Subject: Technical Team Meeting #8

Project: I-70 Peak Period Shoulder Lane

Project No: 215164

Meeting Date: December 16, 2013

1. *Off Peak—Normal*. There will be a series of FHWA signs required by MUTCD.

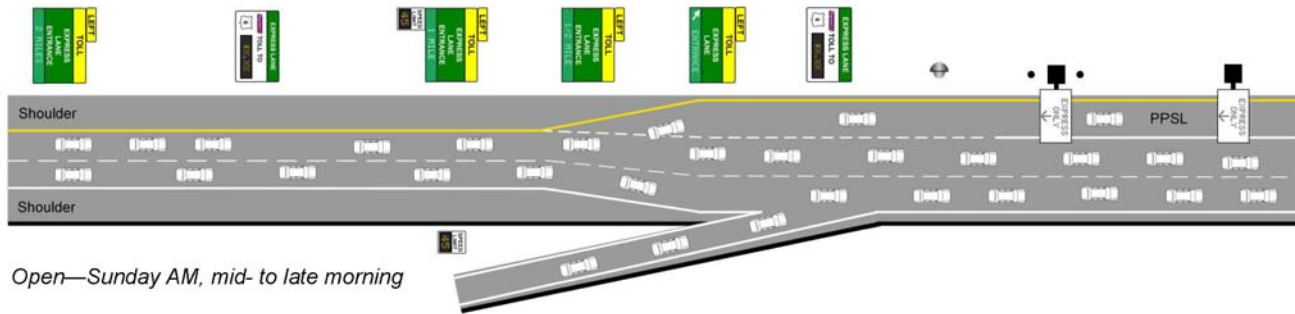
- a. *Cindy Neely*: During non-peak time when it's saying closed, what you are telling the driver is that he cannot get in that lane? If I have a flat tire, are you telling me that I cannot get in that closed lane?

- b. *Phyllis Adams*: Instead of closed, could it say emergency use only?
- c. *Cindy Neely*: What we prefer is that 95% of the time the signs are dark, that they are not flashing at us all day every day—if they are not used.

- d. We will work through the issue of letting people know that during off-peak, this lane is a shoulder. There won't be restriping needed. There will be a sign at the entrance that tells people that in 2 miles, this lane becomes an express lane. We will have that during final design.

- e. For the user's perspective—there will be an electronic message that says breakdown lane, emergency only, or it could be just dark.
- f. For EMS, it's a shoulder so they can use it as they use it today. It would be on the left side.

- i. Variable message signs—we can't get rid of them because they are reserved for other messaging—like chain law, road weather advisory. They need to remain in place because they have a current use. These are two distinct message signs and we don't see how we can consolidate signs.

2. *Open—Sunday AM, mid- to late morning.* Traffic starts to build.

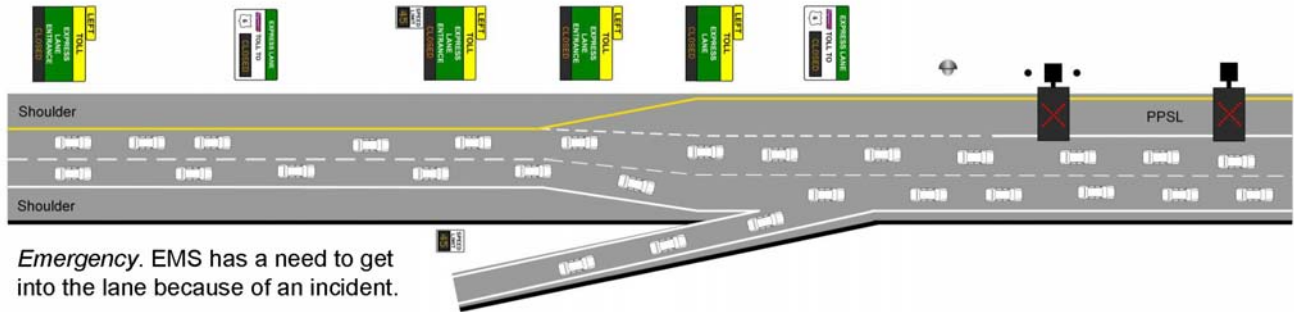
- c. EMS perspective—would continue to use the corridor as is, assuming there is nothing going on in the corridor for emergency response.
- d. Are vehicles with 3 passengers allowed on the express lane? Response: Yes, but all vehicles are tolled.

- e. *Cindy Koch:* Go/no go would be based upon the perpetual monitoring by the CDOT Traffic Operations Center? Response: There could be a scenario where traffic is so light that the lane would not be open, or if there is an accident it could be closed.

- f. *Cindy Koch:* When you said swept, you mean visually? Response: Yes, that is correct.
- g. What is the distance between point-of-entry and when the solid line starts to the end of the entry? Response: That will be 3,000 feet or more, depending on where we start exactly. That would be determined during design.

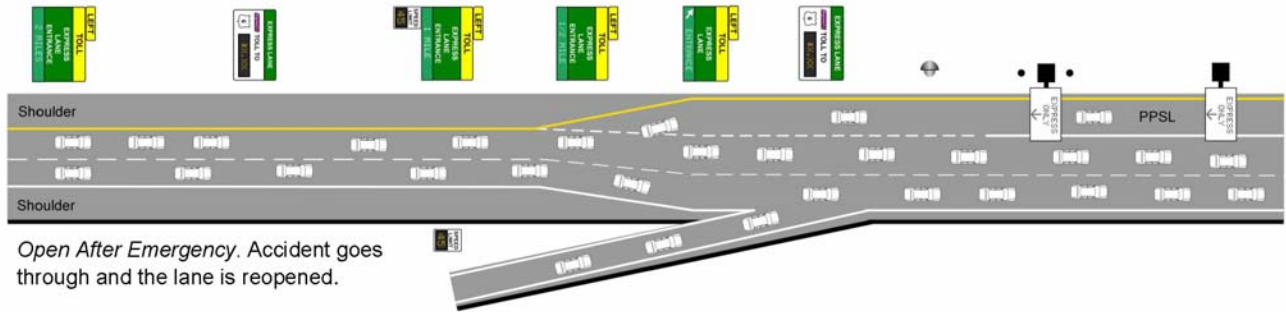
- Emergency.* EMS has a need to get into the lane because of an incident.
- If they are in the lane and need to get out for emergency vehicles, do they need to cross the white line? Response: Yes, they need to. It's going to be a learning process to see what people respond to in the corridor, and sign messaging can be modified accordingly.

- Cindy Koch:* When you have an accident, right now you are telling people to pull off the road. While they are in the lane, you're telling them to get out. I have done the same many times—they would take more than just that left lane. There would be confusion. Response: Yes, it would be challenging. There would be different scenarios as well.

- Jim Bemelen:* I would suggest not to put red X's all the way through simultaneously. Response: Yes, it might be most efficient to let people flush down. That would be a process that needs to be refined.

- Cindy Neely:* Are we putting up 12 cameras? Response: We are putting in CCTV cameras where there are gaps right now. We will have full coverage if the cameras are in operational. Twelve was just an estimate.
- Is it CDOT's function to maintain those cameras? Response: Yes, CDOT is doing maintenance right now on all their cameras; they are going to add these new cameras.

4. *Open After Emergency*—Accident goes through and the lane is reopened.

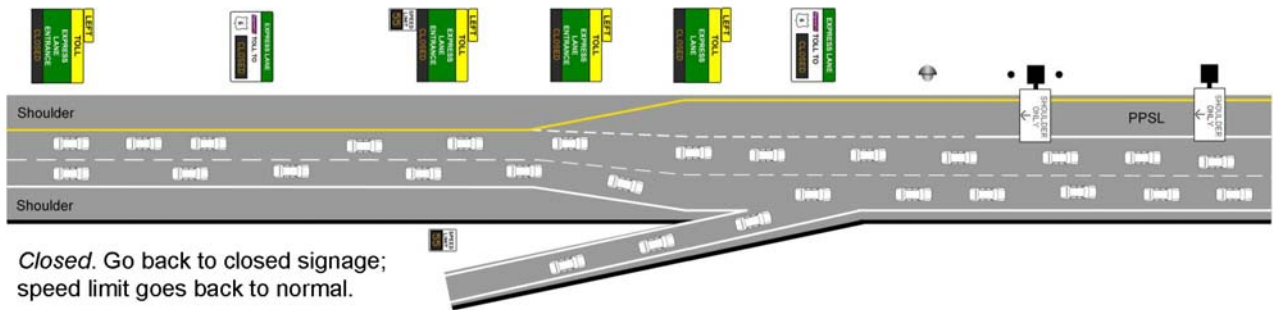
- a. *Cindy Neely*: What does that do to the individual toll charge? Response: Once an incident happens, it gets logged here; then the operations would need to notify E-470 that at 1:15 PM to 1:45 PM, for example, we had to close the lane and to void the toll. This procedure is already in place with E-470 for the I-25 reversible lanes right now.
- b. *Phyllis Adams*: If I was already on the lane when the incident happened, does that mean I would not be tolled? Response: Potentially, yes.

5. *Closed*—Go back to closed signage; speed limit goes back to normal.

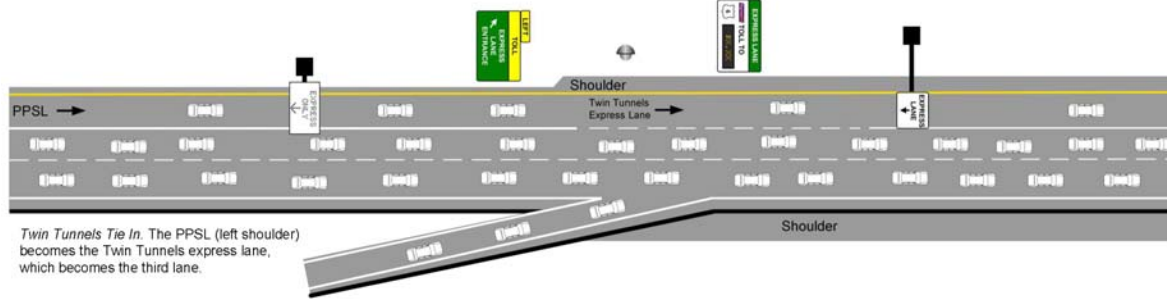
- a. Does it make sense to only toll it for 2 miles? Response: That's more driven by the fact that it is third lane year-round, rather than an express lane. The lane through the tunnel will be open 365 days a year.

- b. *Adams Phyllis*: This section would also be tolled during peak period? Response: That is correct.
- c. *Cindy Neely*: At this point, we are being approached by CDOT operations—that they want to run buses on the shoulder this winter. We have work to do to make a shoulder that's operational. Does CDOT have a complete set of signs for having this bus operation on the shoulder? What are we doing here? How do these things integrate? Response: CDOT is talking about eastbound bus on shoulder operations, just to see if there is any hope of it working, because 10 feet is pretty narrow. They did some tests with a Greyhound bus that was able to run on a 10-foot lane.

- d. *Carol Kruse*: Not familiar with the corridor as people who drive it all the time. It's going to be confusing. Eastbound shoulder lane coming into a third lane? How much time do I have as a driver, when I am trying to pay attention to driving?
